**METROPOLITAN DEVELOPMENT COMMISSION** **September 26, 2024**  
**HEARING EXAMINER**

**Case Number:** 2024-CZN-829 / 2024-CVR-829 (Amended)

**Property Address:** 707 East 22nd Street (Approximate Address)

**Request:** Rezoning of 0.07-acre from the C-3 district to the D-8 district to provide for a two-unit multi-unit house.

AMENDED SITE PLAN

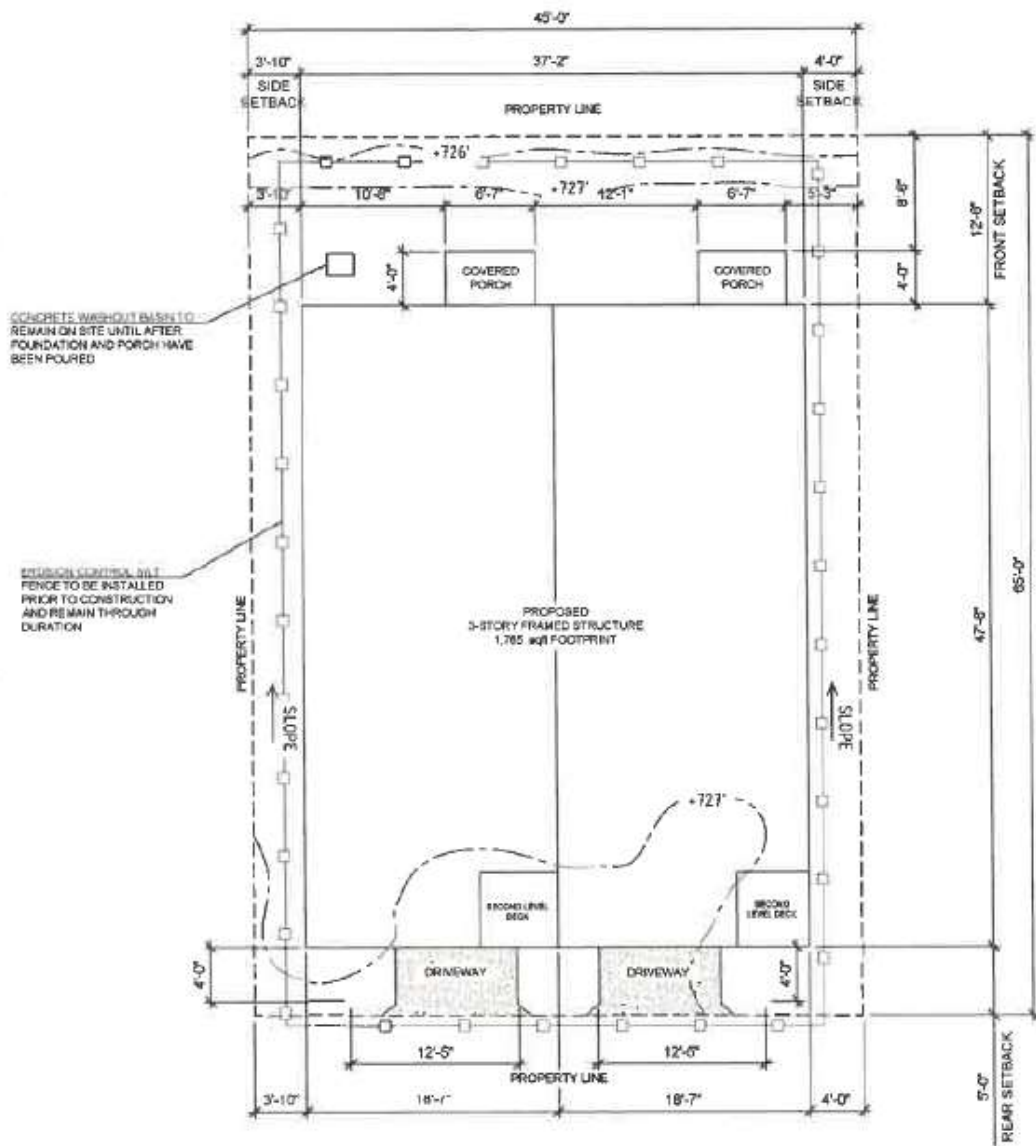
**Amendment:** The petitioner filed a revised site plan and provided building elevations and floor plans for the proposed multi-unit house that exceeded the height and story limitation.

The new site plan indicates two driveways to be proposed at the rear of the site for the proposed garages on the first floor of each unit. The issue is that the site does not have access to the proposed garages. The property to the south has a private drive along the abutting property boundary, which would require an access easement to be granted from the southern property owners before permits can be issued.

Without a definitive answer whether an access easement would be granted, staff does not find reason to support a request that is partially due to the proposed garage use of the first floor. In staff's opinion, the filing of the variances is premature and should be considered after the access issue has been addressed.

If the landscape variances were withdrawn so the landscape requirements could be met and if the petitioner commits to not develop garages with the proposal, then staff could recommend approval of the variances. A revised site plan and revised floor plans would need to be submitted for Administrative Approval.

FIRST FLOOR PLAN

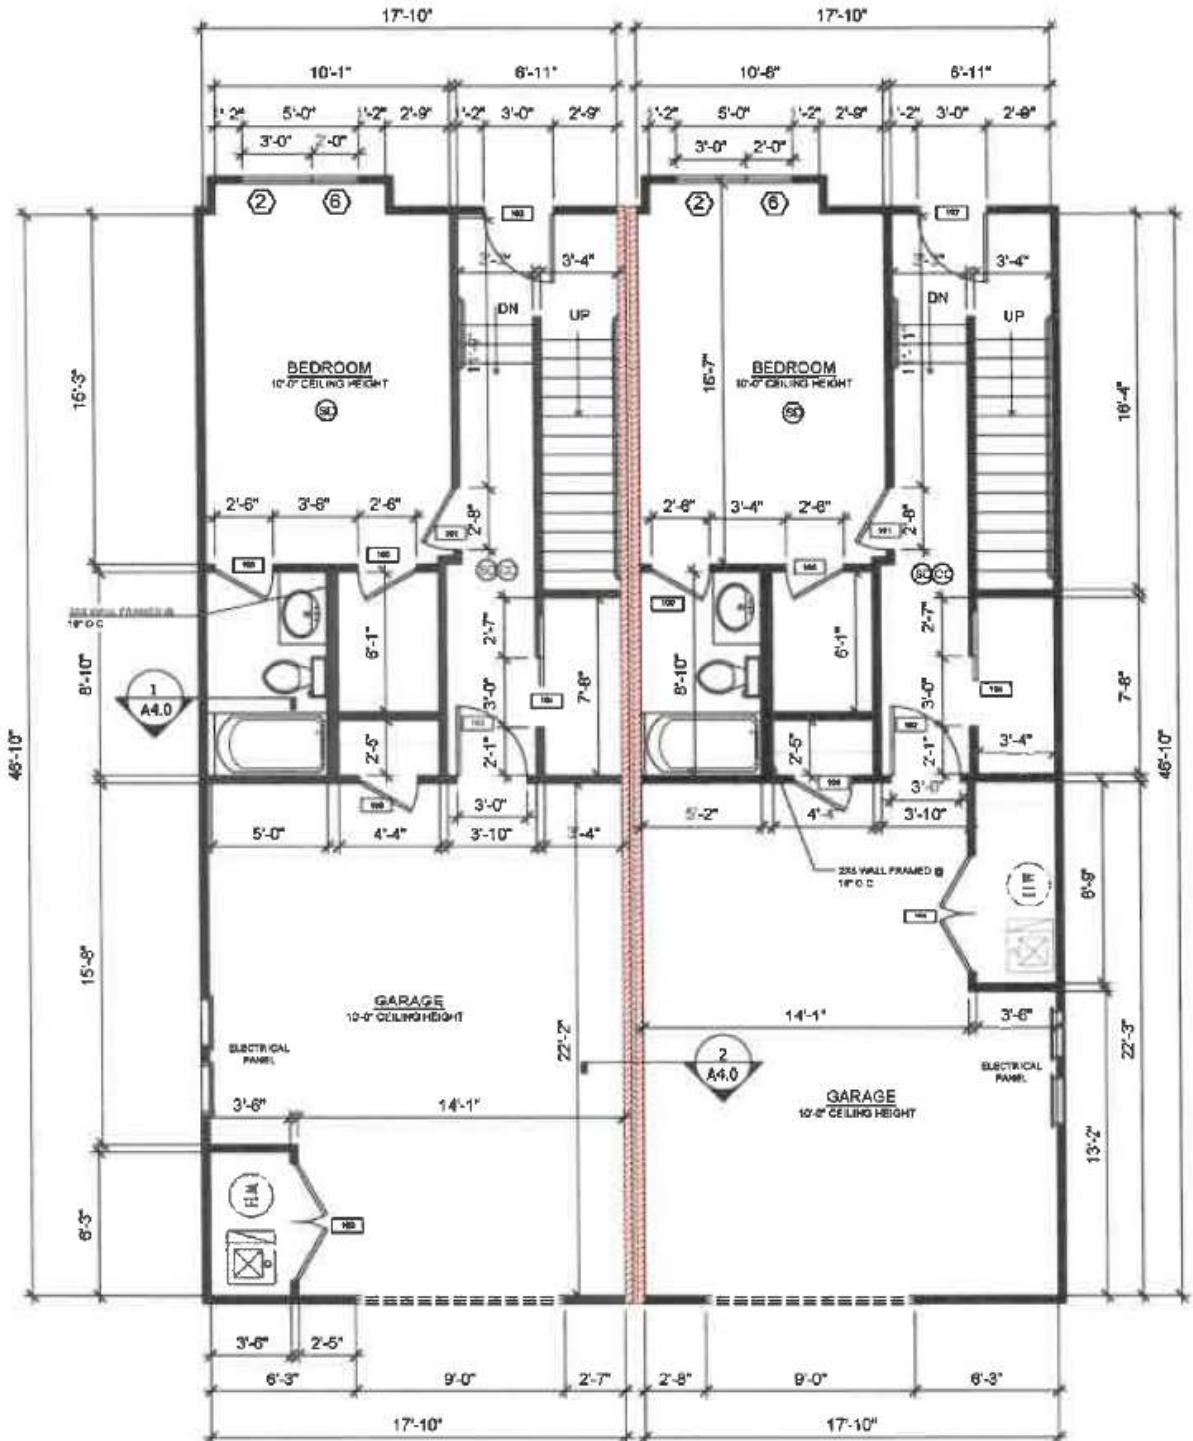
If the garages were to be eliminated, then the floor layouts could be rearranged to possibly meet the 2.5 story limit. The height of the proposed building could also be adjusted to meet the 35-foot height limitation without any issues.

ELEVATIONS

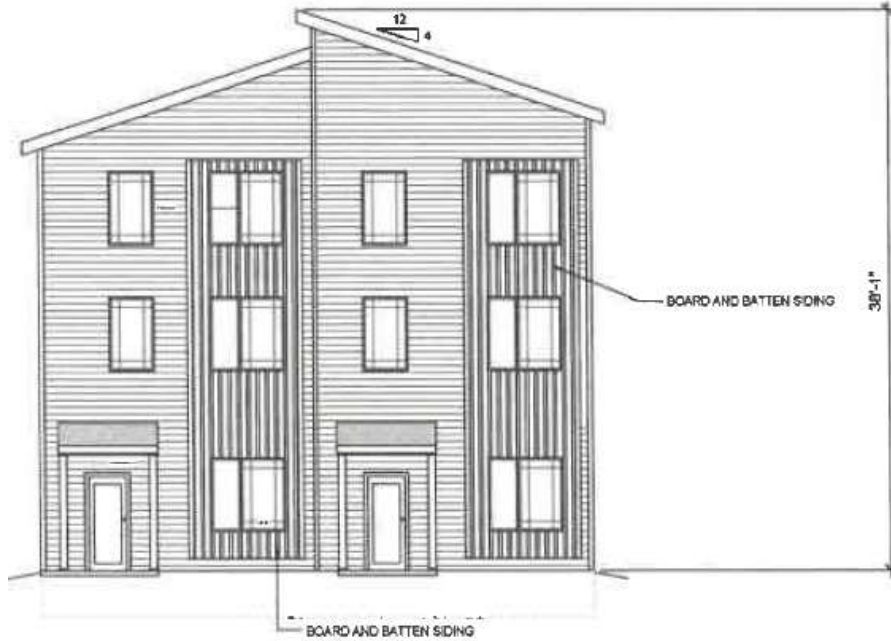
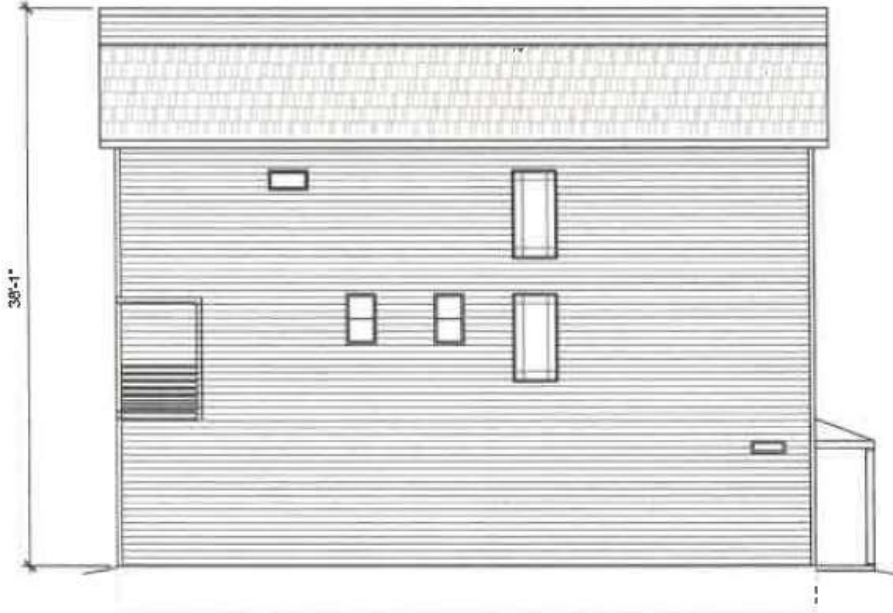
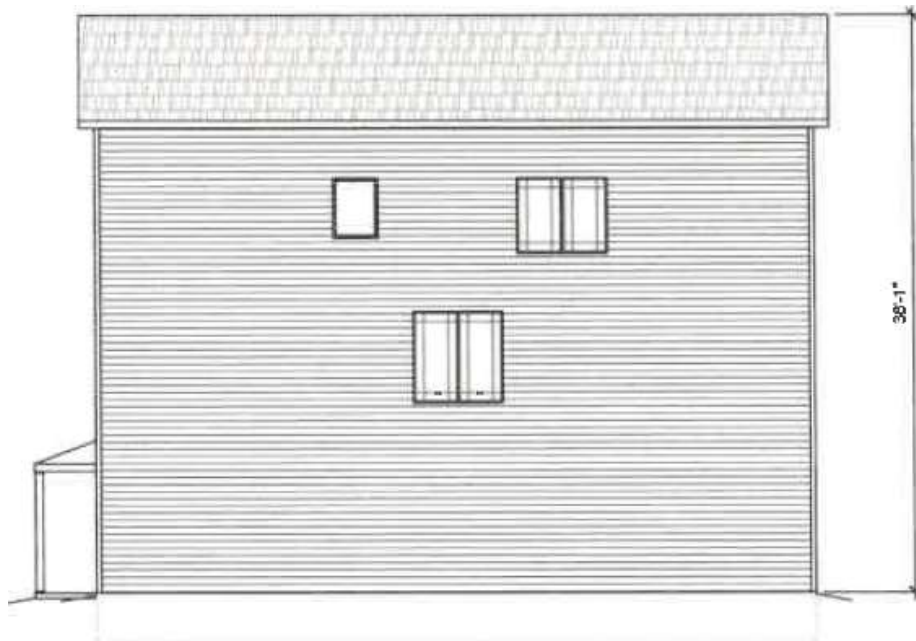
The Ordinance defines a half story as "the space under a sloping roof that has a line of intersection of the roof and exterior wall face not more than 2 feet above the floor level, and where the possible floor area with headroom of 7 feet or more is no greater than 60% of the total floor area of the story directly beneath".
